MEMORANDUM

MEETING DATE: September 19, 2026

RE: Right of Way Permit Application, Christopher Hauck & Luis Allen: 731 Pleasant Street

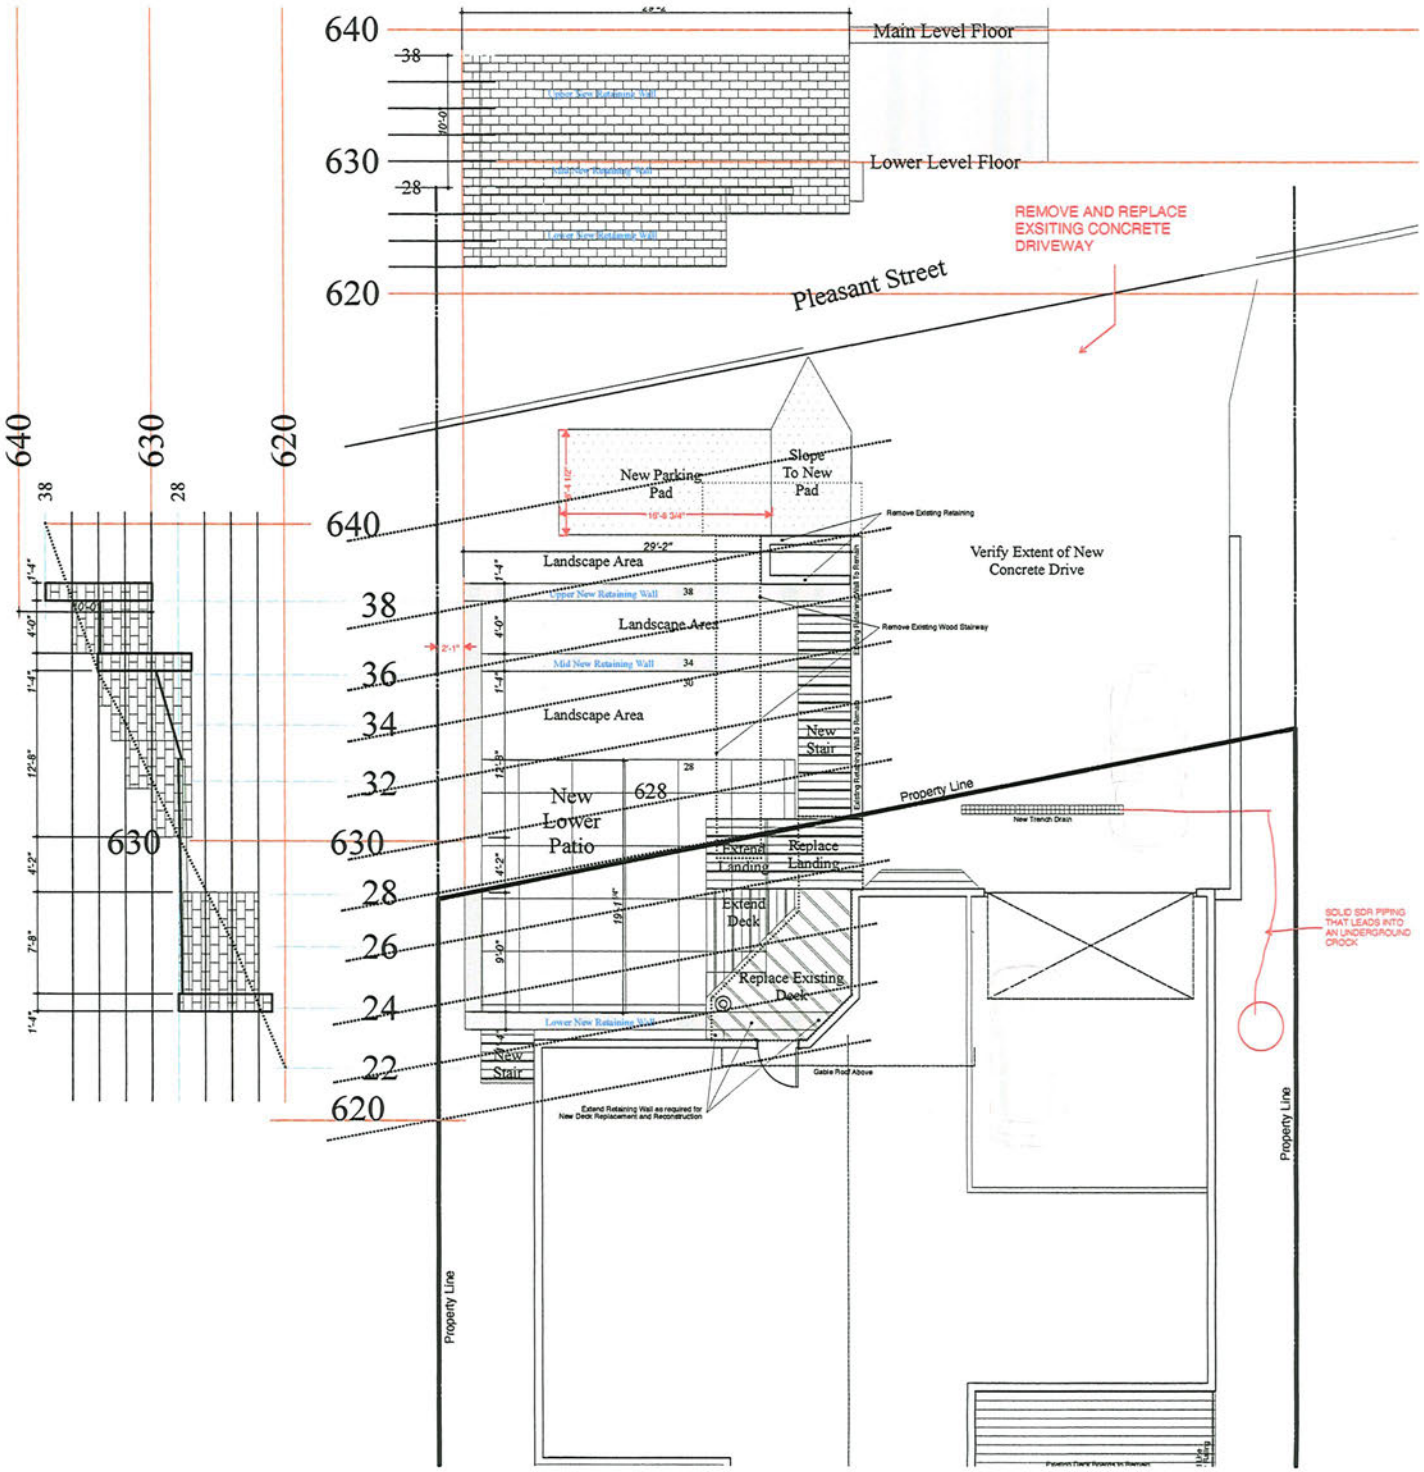
The Engineer also noted historical drainage issues at the rear of the property and recommended that the proposed underground drainage system include an appropriately sized stone-bedded leach basin and perforated sock tile/French drain, with overflow designed to avoid impacts to adjacent properties or slope erosion. Drainage for the proposed lower patio should also be addressed, potentially through a similar leach basin system.
